Acceptable Solution E2/AS2

1.0 Earth buildings

1.1 Modifications to NZS 4299

Figure 5.11 Soffit to wall junction
A) Flat soffit

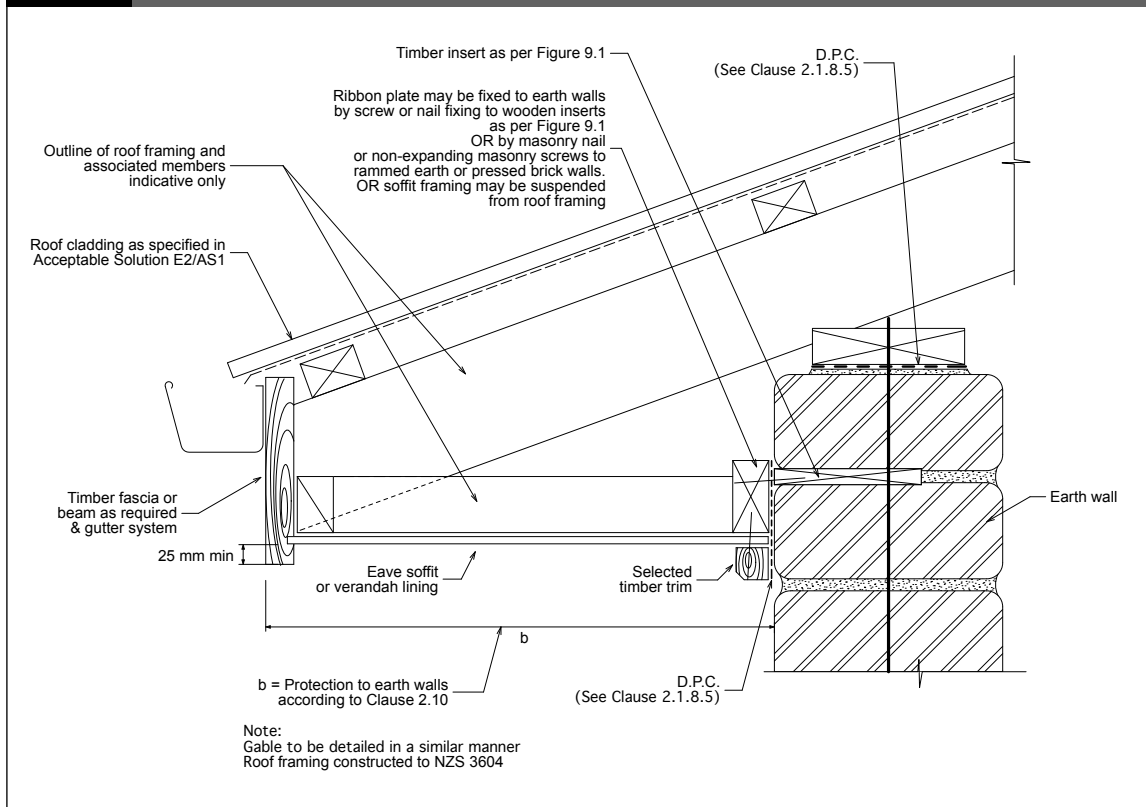
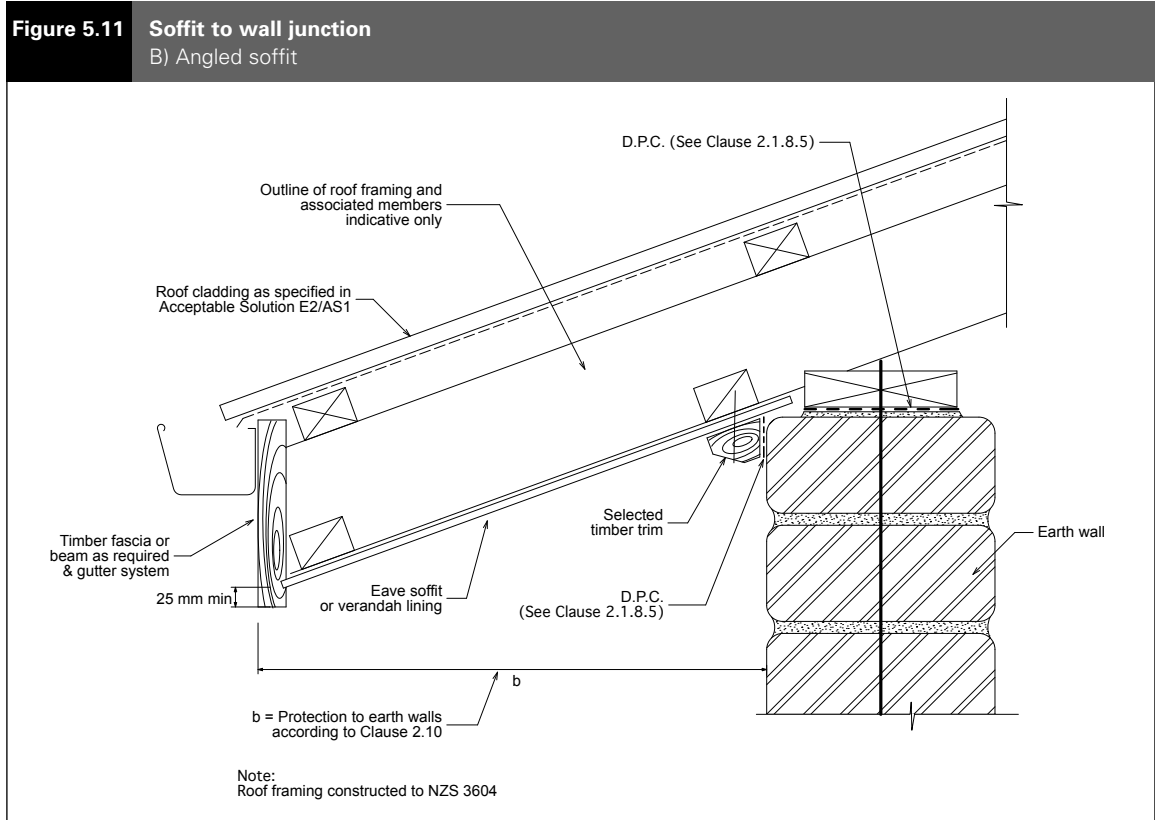
Clause 5.1.12 Add new Clause and Figure:

The junction between the soffit and the earth wall must be constructed as shown in Figure 5.11.

Figure 5.12 Timber-framed gable to earth wall

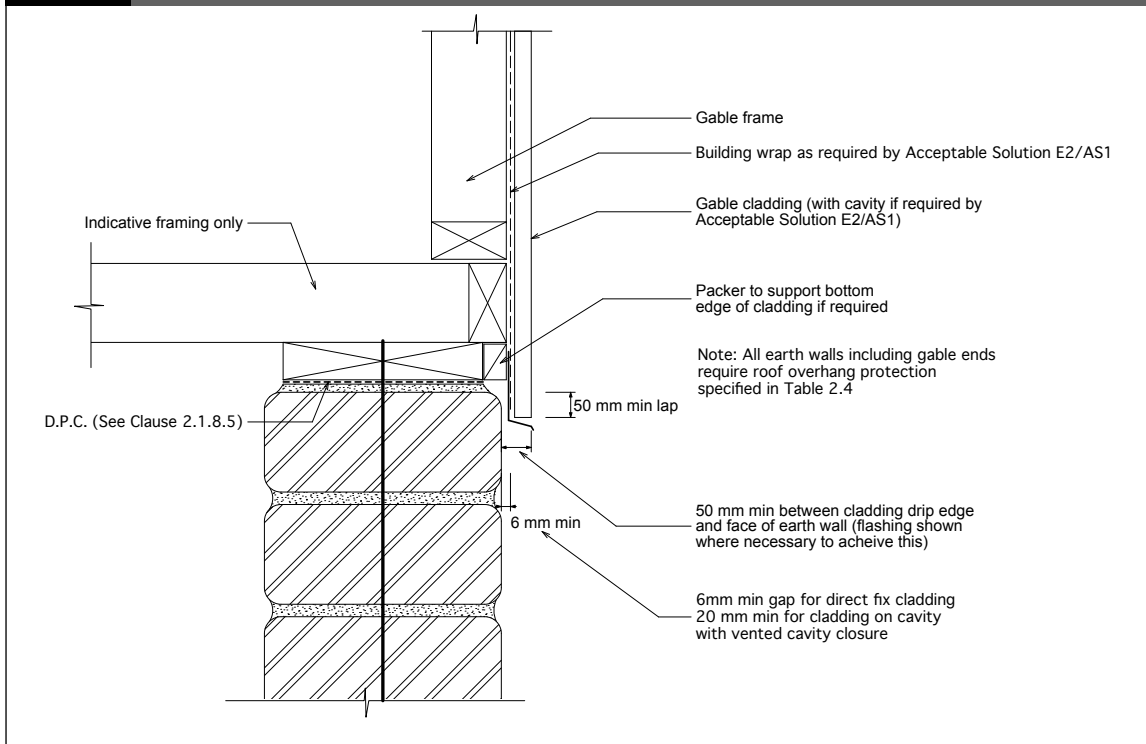
Clause 5.13 Add new Clause and Figure:

The junction between timber-framed gable walls and earth walls must be constructed as shown in Figure 5.12.
